# Access Compliance Report

## Public Rights-of-Way

### (Curb Ramps)

Intersection ID: 12848	Main Street: S_MINT_ST	Cross Street: W_PALMER_ST	Location: N
ADA ID: 1117E6766847	Ramp Type: PerpDiag	Initial Pass/Fail: Fail	Overall Compliance: No
Severity Score: 37.5			
Codes/Mitigation Info/Possible Solution		Field Measurements/Component Compliance

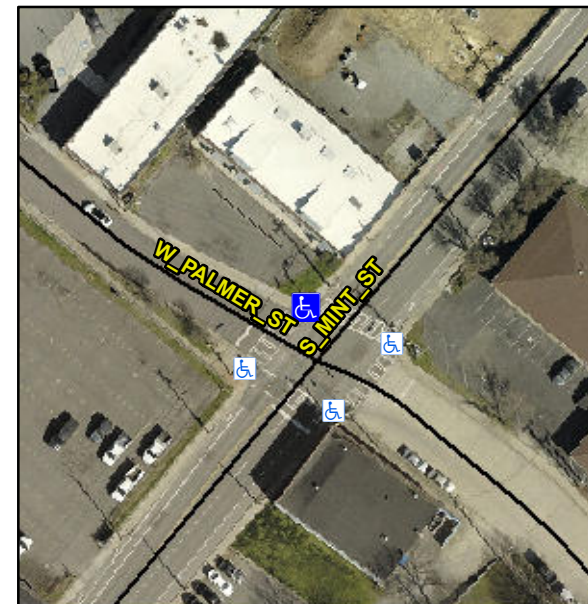
**Not Found, R304.2.2, R304.5.3**

Compliance	Description	Data	Compliance	Description	Data
N/A	Ramp Length (in)	48.0	No	Ramp Slope (%)	13.2
Yes	Ramp Width (in)	48.0	No	Ramp XSlope (%)	5.8
N/A	Flare Type LT	N/A	N/A	Flare Type RT	N/A
N/A	Flare Slope LT (%)	N/A	N/A	Flare Slope RT (%)	N/A
N/A	Flare Traversable LT?	N/A	N/A	Flare Traversable RT?	N/A
N/A	Landing Length (in)	N/A	N/A	DWS Provided?	N/A
N/A	Landing Width (in)	N/A	N/A	DWS Contrast?	N/A
N/A	Landing Slope (%)	N/A	N/A	DWS Length (in)	N/A
N/A	Landing X Slope (%)	N/A	N/A	DWS Full Width?	N/A
N/A	Landing Curb? (Y/N)	N/A	N/A	DWS Offset (in)	N/A
N/A	Shared Landing?	N/A			
N/A	Gutter Ponding?	N/A	N/A	Gutter Slope (%)	N/A
N/A	Gutter Lip Ht (in)	N/A	N/A	Gutter X Slope (%)	N/A
N/A	Painted X Walk1?	Yes	N/A	Painted X Walk2?	Yes
	X Walk 1 Direction	To SW		X Walk 2 Direction	To SE
N/A	X Walk 1 Width (in)	114.0	N/A	X Walk 2 Width (in)	108.0
	X Walk 1 Slope (%)	4.0		X Walk 2 Slope (%)	2.6
	X Walk 1 X Slope (%)	2.5		X Walk 2 X Slope (%)	4.2

**Remove & Replace Curb Ramp With Two New Directional Ramps or Equivalent.**
